RESPONSE TO NRC QUESTIONS ON STEAM GENERATOR TUBE INSPECTION

PREPARED BY FLORIDA POWER AND LIGHT COMPANY

ST. LUCIE UNIT 2 - DOCKET NO. 50-389

Reference: NRC letter dated April 8, 2003, Saint Lucie Nuclear Plant, Unit 2:
Upcoming Steam Generator Tube Inservice Inspection (TAC No. MB81 34)

Axial ODSCC at Eggcrates Screening Limits - PSL-2 SG A

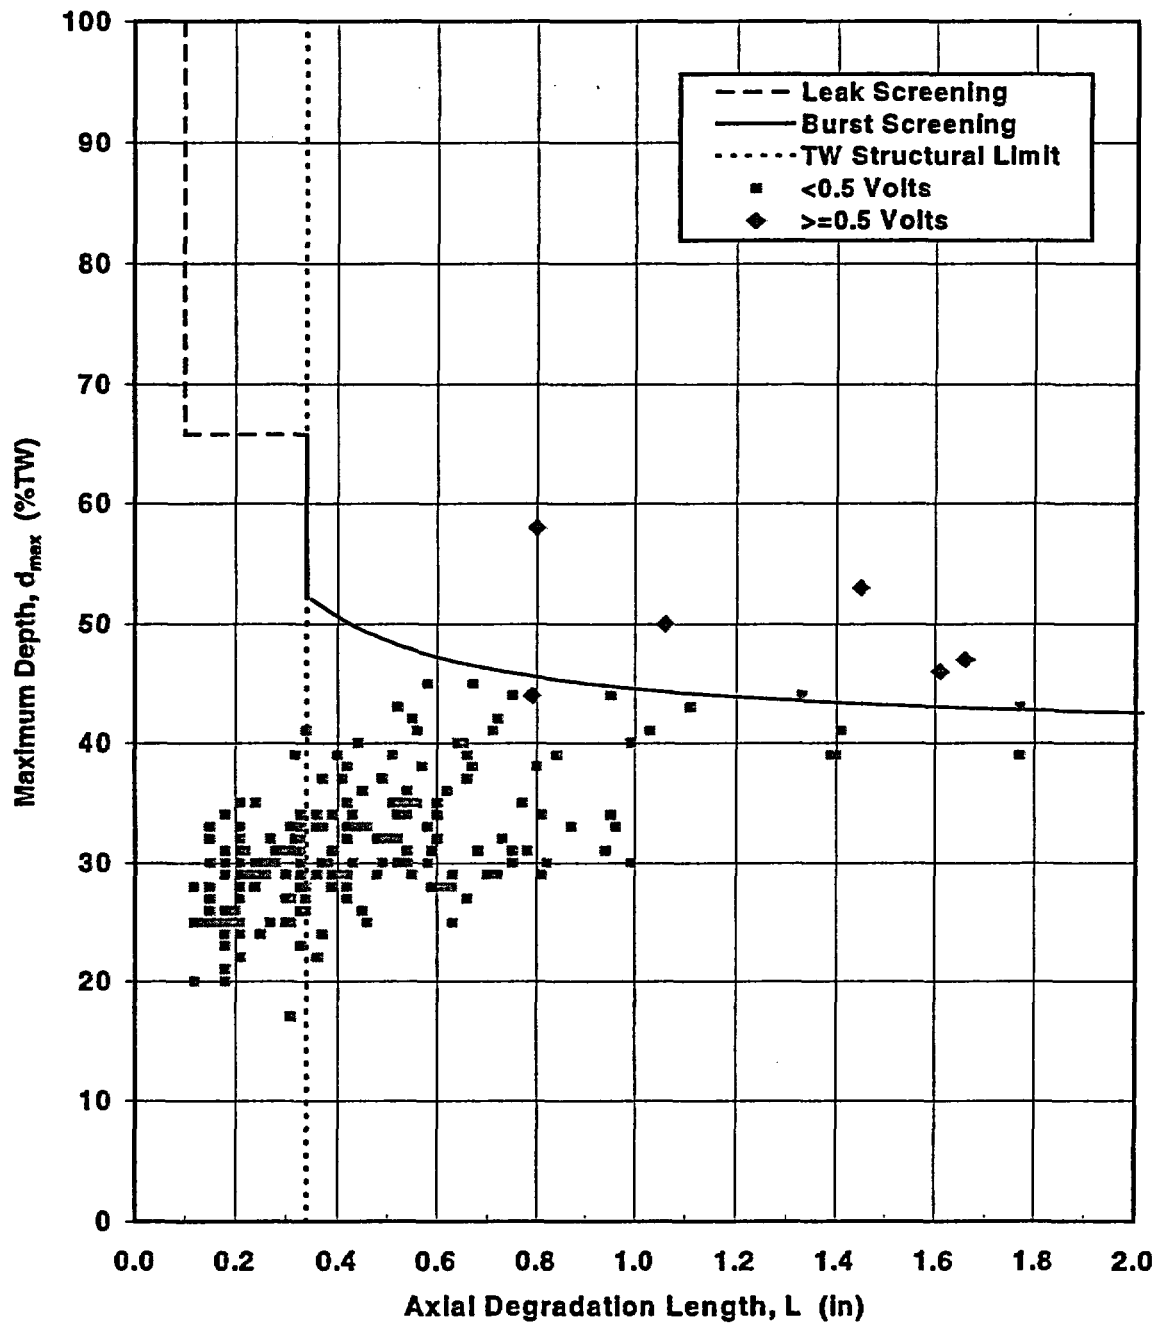
5. Provide a summary of the number of indications identified to-date of each degradation mode and SG tube location (e.g., tube support plate, top-of-tubesheet, etc.). Also provide information, such as voltages, and estimated depths and lengths of the most significant indications.

Initial in situ screening plots are provided for indications reported in the April 2003 inspection to provide a perspective on estimated length, depth and voltage. This initial screening is conservative in that the flaw is modeled by a bounding geometric shape. For example, a circumferential indication is treated as a rectangular-shaped crack where the maximum depth is assumed over the entire flaw length. Flaws exceeding the screening criteria are further evaluated with detailed plus point profiles and structural evaluations are then completed to determine if these flaws require in situ testing. For the flaws evaluated to date, none require in situ testing based on these evaluations.
